Clinton Power Station  
8401 Power Road  
Clinton, IL 61727

Clinton Power Station, Unit 1  
Facility Operating License No. NPF-62  
NRC Docket No. 50-461

Subject: Requested Information from June 25, 2015 Regulatory Conference

Subject: Clinton Power Station 1SX01PC Pump September 2014 Bearing Failure –  
Calculation Summary Report

**Figure A - SEM-EDS Evaluations of Sleeve F Interface**

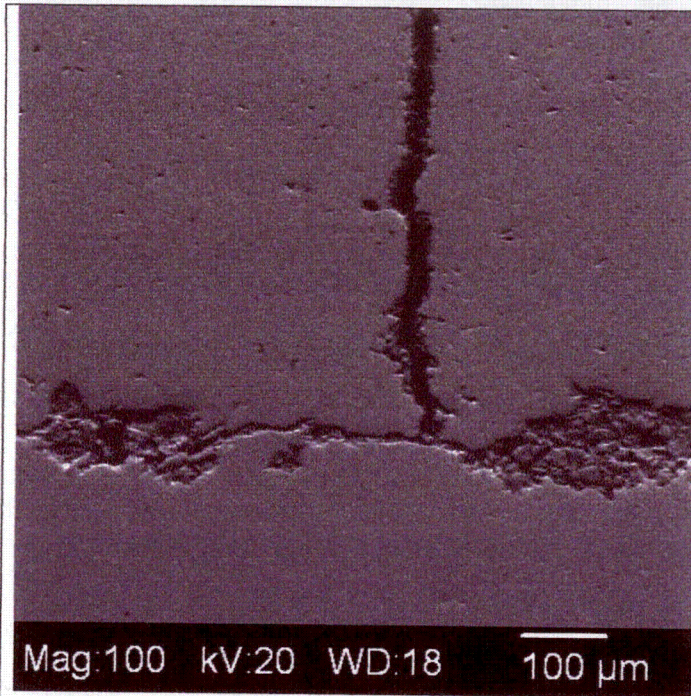
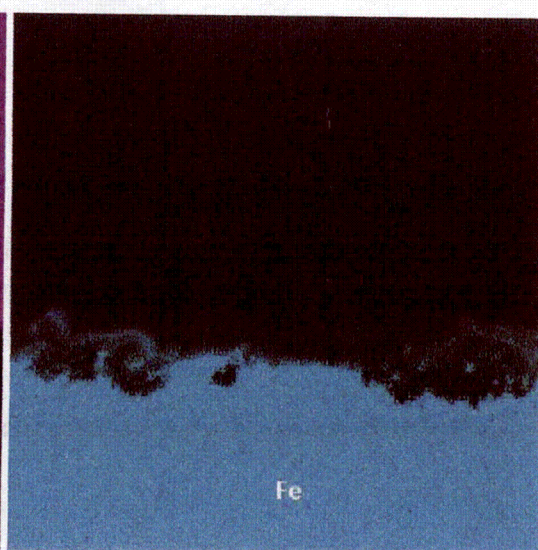
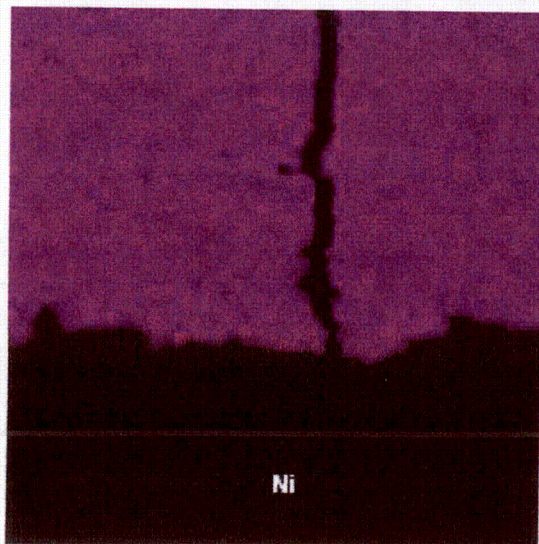
PowerLabs did not find evidence that the hardfacing was welded to the sleeves. Every hardfacing/base metal interface showed a distinct boundary between the sleeve and the coating with no evidence of dilution from welding as shown in Figure A below. Additional metallurgical photos of the interface regions were provided in the following photos of PowerLabs Report CPS-86766.
